HISTORIC AND DESIGN REVIEW COMMISSION

May 18, 2022

HDRC CASE NO: 2022-200
ADDRESS: 323 REFUGIO ST
LEGAL DESCRIPTION: NCB 714 BLK 11 LOT S IRR 63.8 FT OF 14 AT 323 REFUGIO
ZONING: RM-4, H
CITY COUNCIL DIST.: 1
DISTRICT: Lavaca Historic District
APPLICANT: Marcello Martinez/1718 Archtitecture
OWNER: Kevin Allison/ALOHA HOME SOLUTIONS INC
TYPE OF WORK: Construction of a rear addition, rehabilitation, construction of a new front porch
APPLICATION RECEIVED: March 31, 2022
60-DAY REVIEW: Not applicable due to City Council Emergency Orders
CASE MANAGER: Claudia Espinosa

The applicant is requesting a Certificate of Appropriateness for approval to:

1 FLOOR PLAN
1/4" = 1'-0"
0' 2' 4' 8' 12'

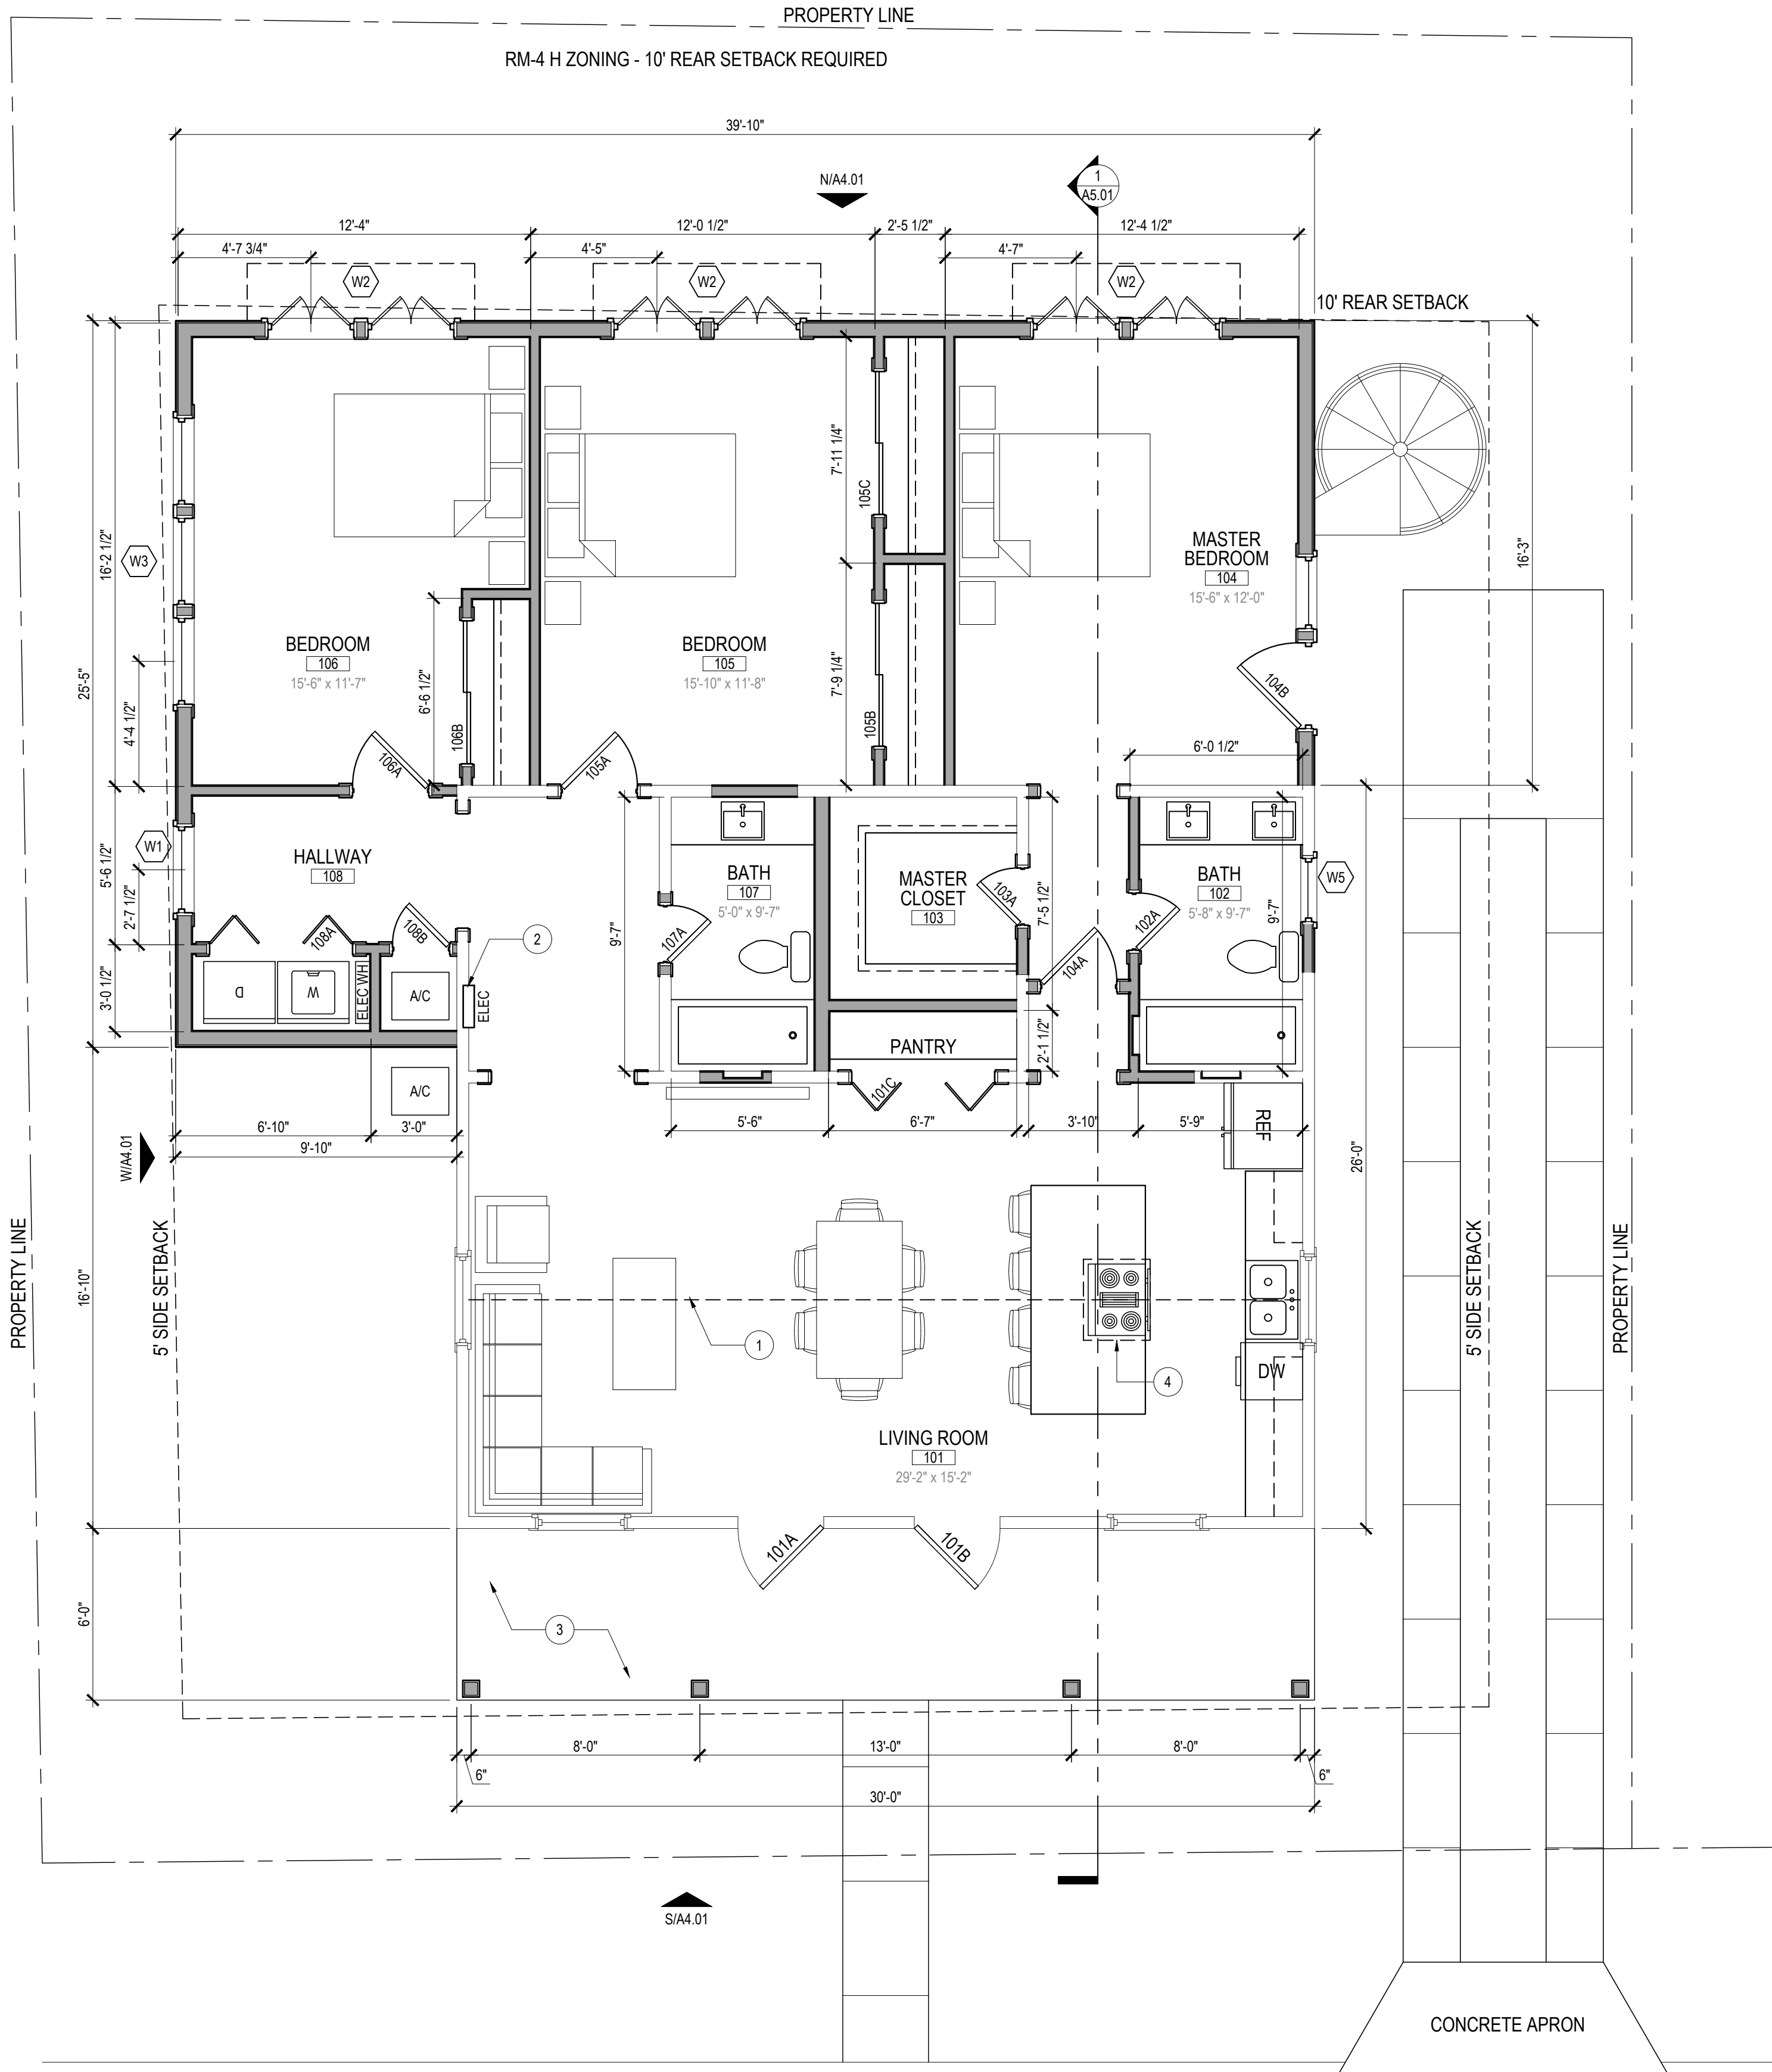
- e. **ADDITION: LOT COVERAGE** – The applicant has proposed to construct a 1-story rear addition. The total square footage of the primary structure is 780 square feet. According to the Historic Design Guidelines, the building footprint for new construction should be limited to no more than 50 percent of the total lot area, unless adjacent historic buildings establish a precedent with a greater building to lot ratio. A building footprint should respond to the size of the lot. The applicant has proposed a total square footage of 1,504 square feet for the primary structure and addition with a total lot coverage of 42 percent. Staff finds the proposal consistent with the Guidelines.

- f. **ADDITION: MASSING AND FOOTPRINT** – The applicant has proposed to construct an approximately 724-square-foot, 1-story rear addition. The original primary structure is 780 square feet. Guideline 1.B.i for Additions stipulates that residential additions should be designed to be subordinate to the principal façade of the original structure in terms of scale and mass. Guideline 2.B.iv for Additions states that the building footprint should respond to the size of the lot. An appropriate yard to building ratio should be maintained for consistency within historic districts. Residential additions should not be so large as to double the existing building footprint, regardless of lot size. While the proposed addition will not double the existing building footprint, the proposed addition is not subordinate to the principal façade and extends beyond the footprint of the primary structure and will be highly visible from the public right-of-way. Staff finds the proposal inconsistent with the Guidelines.

- i. That the applicant reduces the overall massing of the rear addition and proposes a rear addition that is inset from the existing wall planes on finding f.
- ii. That the applicant proposes a roof form that is similar to the historic structure or appropriate for the style and does not modify the existing roof form based on finding g.
- iii. That the applicant updates the proposal to feature windows of traditional proportions on the south (front) elevation based on finding j.

Existing Elevation

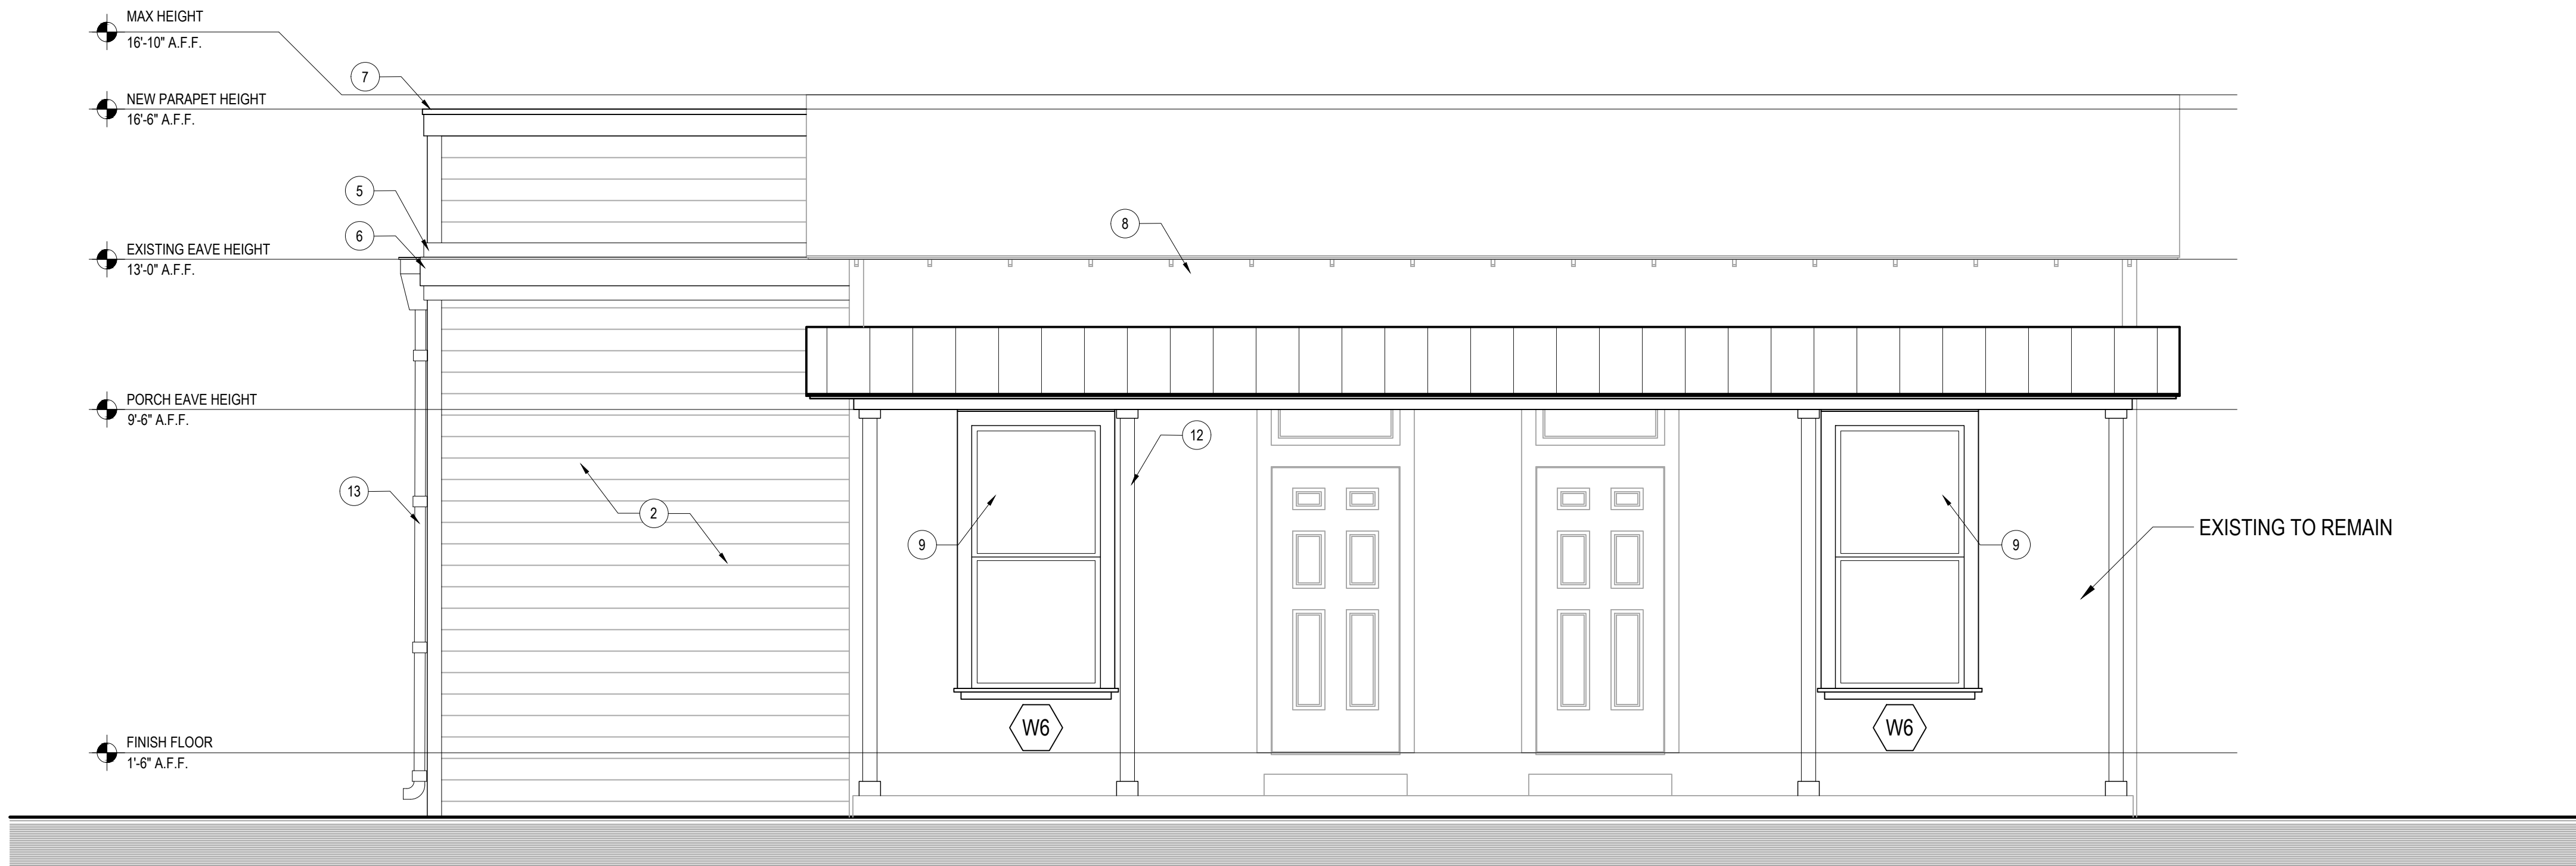
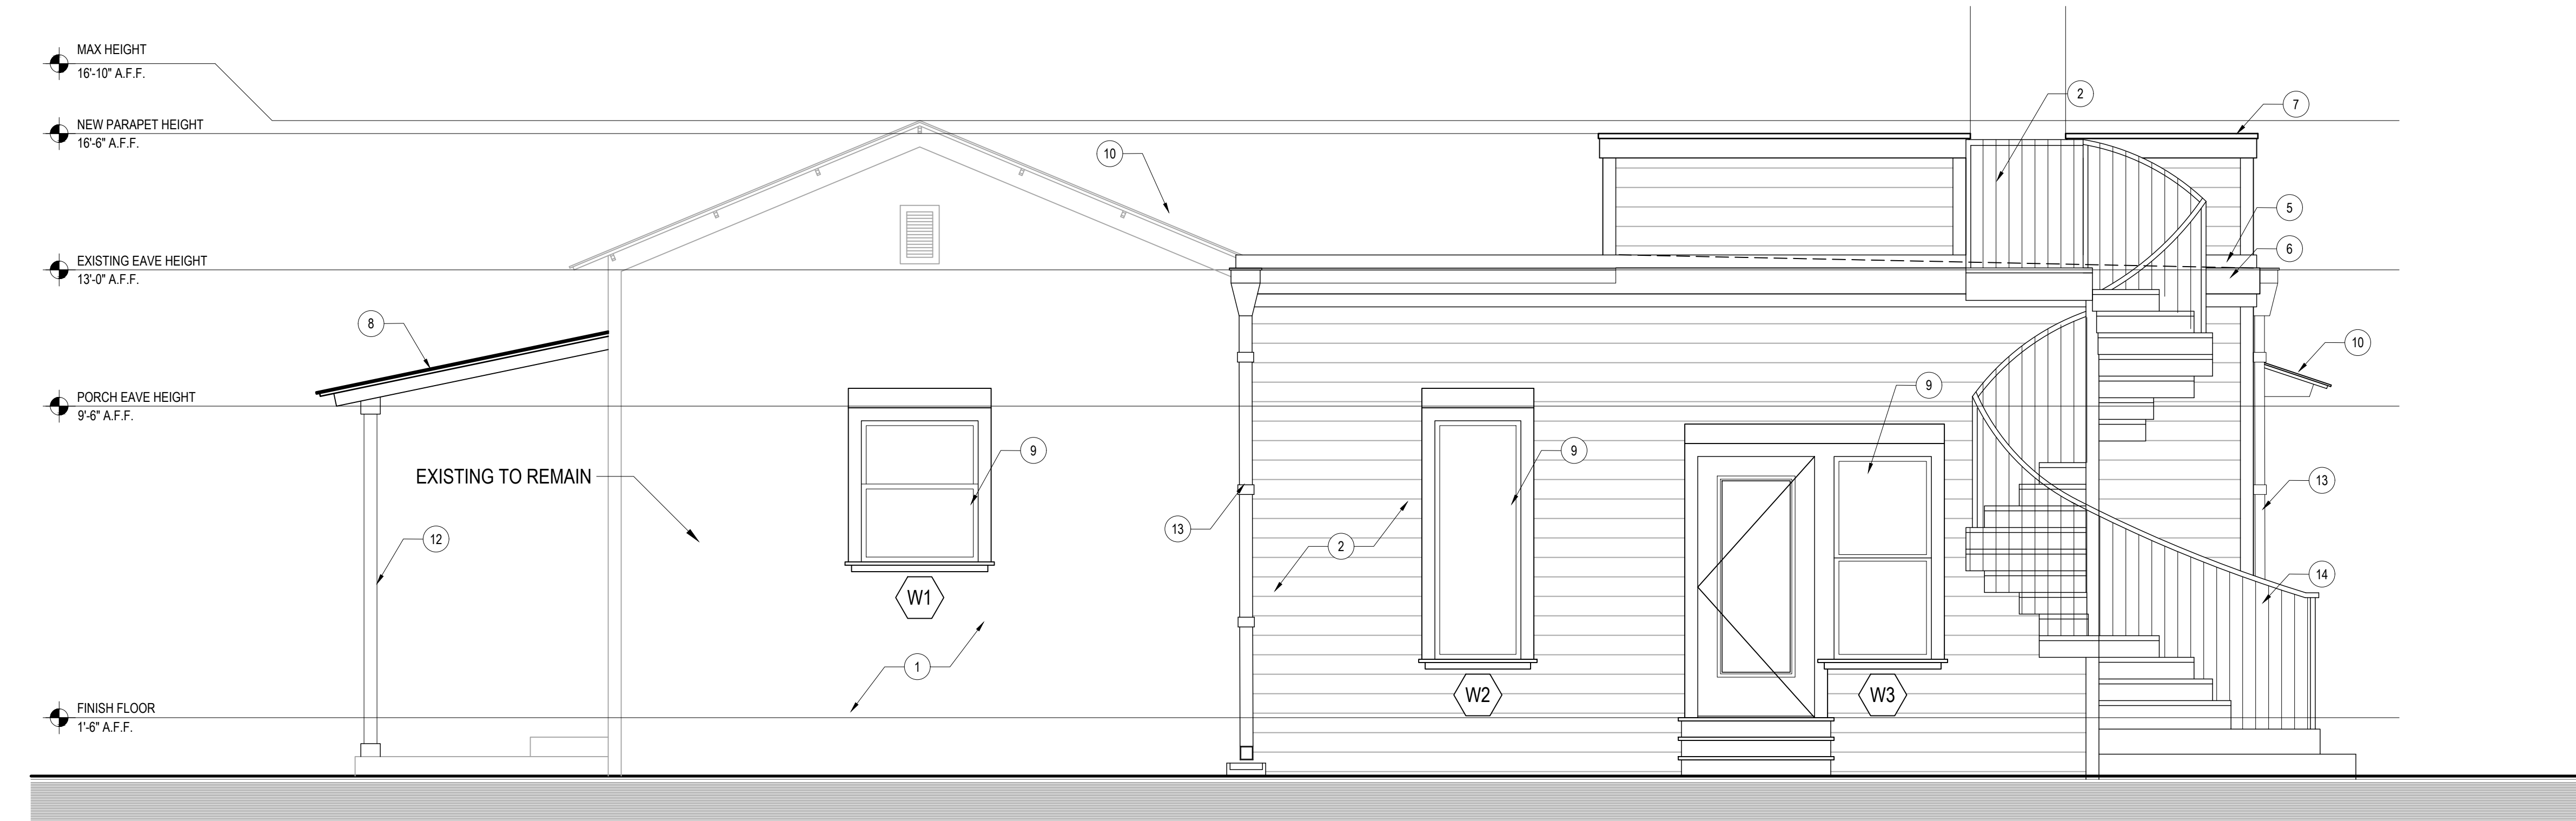
- b. **COMPLIANCE** – During the review of the application, staff determined that the previously existing divided lite and two-over-two wood windows were replaced with the existing vinyl faux divided lite windows at least one year ago by the previous property owner without approval. The property is not currently in compliance. Staff recommends that the current property owner replaces the noncompliant replacement windows with appropriate wood windows. Once the property is in compliance, rehabilitation work will be eligible for the Substantial Rehabilitation Tax Incentive.

- d. **FRONT PORCH CONSTRUCTION** – The applicant has proposed construct a shed roof front porch that spans the center of the front facade and uses the existing concrete front porch slab. The applicant has proposed to construct the front porch with a composition shingle shed roof that is an extension of the existing roof form and 6"x6" wood columns. The 1896 Sanborn Map shows that the structure originally featured a full-width front porch. Google Street View photos from 2011 show a modified front porch in the same configuration as the proposed front porch but with a traditional shed roof located below the front façade roofline on metal post supports. Guideline 7.B.v for Exterior Maintenance and Alterations states that porches, balconies, and porte-cocheres should be reconstructed based on accurate evidence of the original, such as photographs. If no such evidence exists, the design should be based on the architectural style of the building and historic patterns. Staff finds that the new front porch should feature a shed roof that is distinct from the roof on the primary structure. Additionally, the installation of a full-width front porch to match the original front porch would be appropriate.

- i. **ADDITION: REAR WINDOW AND DOOR REMOVAL** – The proposed addition will require the removal of three (3) existing faux divided lite replacement windows and one (1) door. According to Guideline 6.A.i for Additions, filling in historic openings should be avoided, especially when visible from the public right-of-way. This element is not visible from the public right-of-way. Staff finds the proposal acceptable given the location of the rear addition and the removal of incompatible replacement windows and encourages the applicant to salvage any reusable material.
